This SB supersedes and replaces SB-912-065 R2/ SB-914-046 R2 dated February 27, 2015.

## SERVICE BULLETIN

# Exchange of floats on ROTAX® Engine Type 912 and 914 (Series)

### MANDATORY

Fig. 1

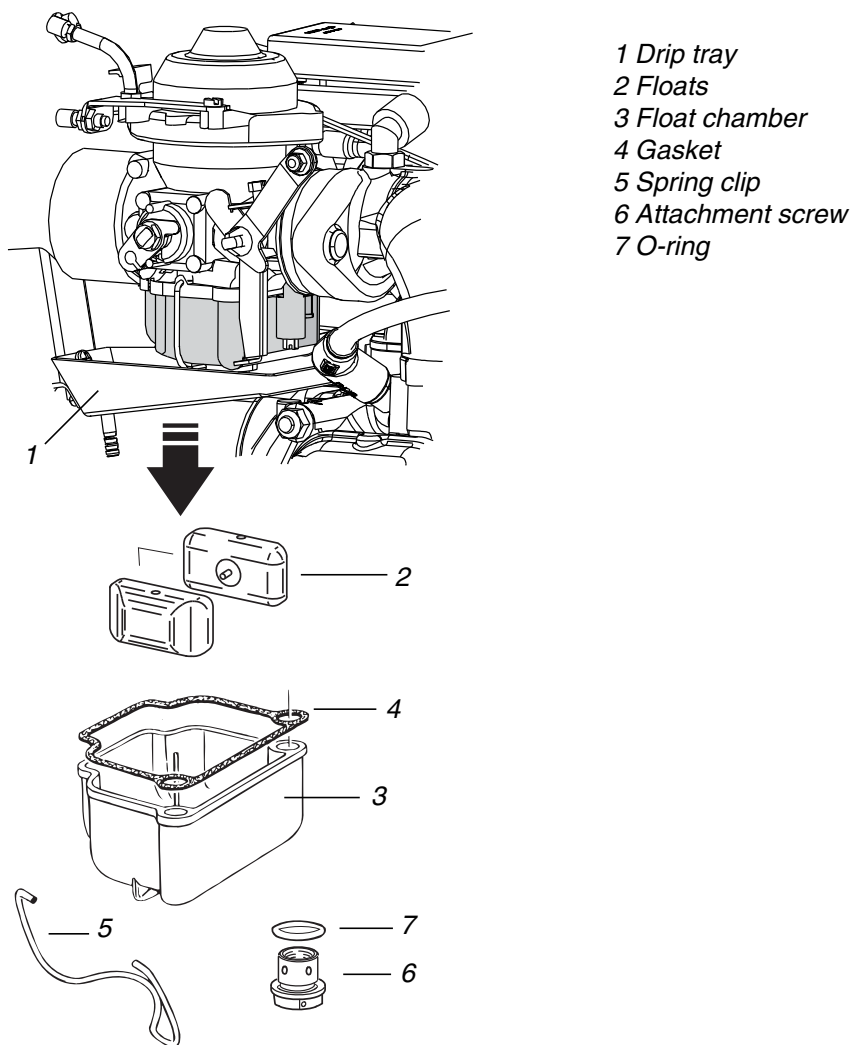
Step	Procedure
1	Remove drip tray (1).
2	Visual inspection of the carburetor and its mechanical actuation.
3	Remove spring clip (5) or for ROTAX 914 Series remove safety wire, loosen cap screw (6) and remove with O-ring (7).
4	Remove float chamber (3), gasket (4) and the two floats (2)

Step	Procedure
1	Remove the gasket (4) from the float chamber and for ROTAX 914 Series exchange the O-ring (7).
2	Install float chamber (3) with gasket (4) and both floats (2).

Step	Procedure
3	Close spring clip (5) or for ROTAX 914 Series install the attachment screw (6) including O-Ring (7) and apply safety wire. Tightening torque of attachment screw 5.5 Nm (48.7 in.lb).
4	Install drip tray (1) and/or accessories according to the instructions of the aircraft manufacturer.
